Addendum No. 6 to the
Mitigated Negative Declaration for the
**Lower American River Anadromous Fish Habitat
Restoration Project**

Prepared for:
City of Sacramento

January 2022

State Clearinghouse No.
2019069088

Figure 1. Change in Area of Potential Effect

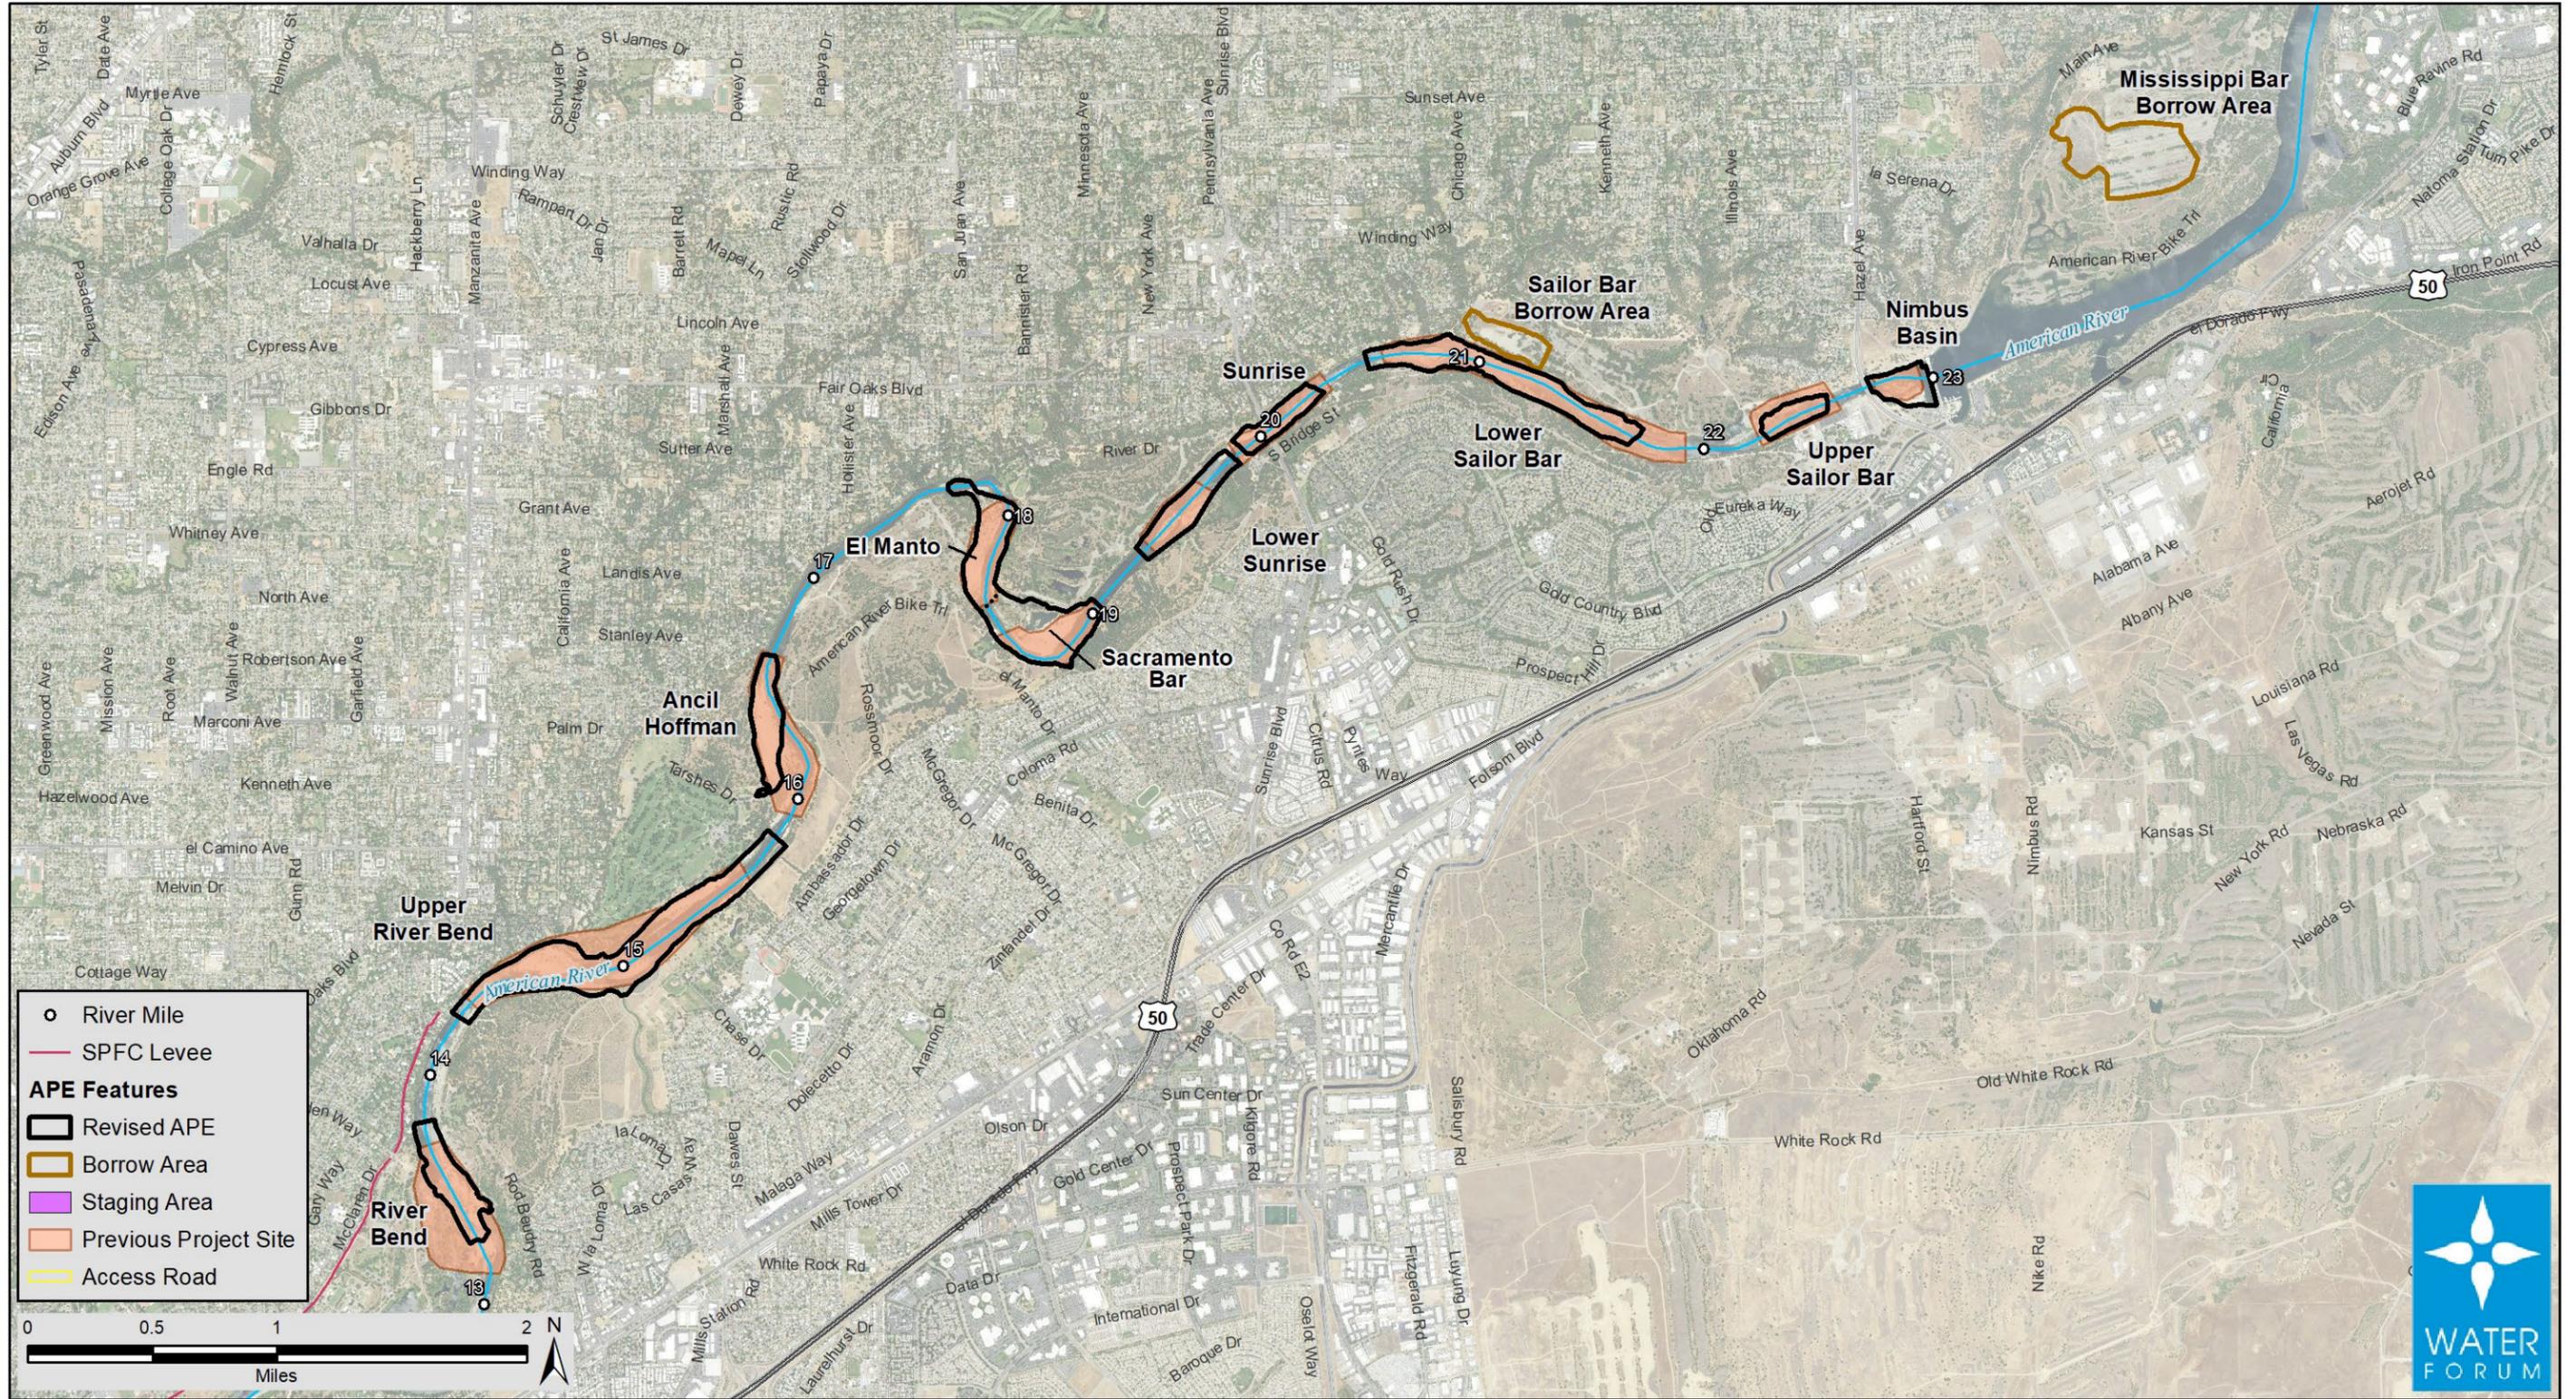
Based on updated construction designs, the project refinements include modification to the project site boundary and APE at all 10 habitat sites to reflect more conservative and precise boundaries for all potential disturbance related to cut and fill, staging, and interim gravel placement that may occur prior to full restoration or enhancement at a given site (See **Figure 1**). A reduction of the project site boundary and APE would occur at all sites except Lower Sunrise, Nimbus Basin, El Manto, and Sacramento Bar, where expansions would occur. The modified project site and APE would result in a net decrease of approximately 92 acres in the overall footprint of the project site and APE.

On January 21, 2022 and January 24, 2022, GEI archaeologist Jesse Martinez conducted a pedestrian survey of areas not previously surveyed at Upper Sailor Bar, Lower Sailor Bar, Sunrise, El Manto/Sacramento Bar, Upper River Bend, and Ancil Hoffman (See **Figure 1**). These areas were selected for survey because review of satellite photographs indicated that these areas might differ in terms of topography or vegetation compared to other nearby areas that were surveyed previously, potentially resulting in differing archaeological sensitivity.
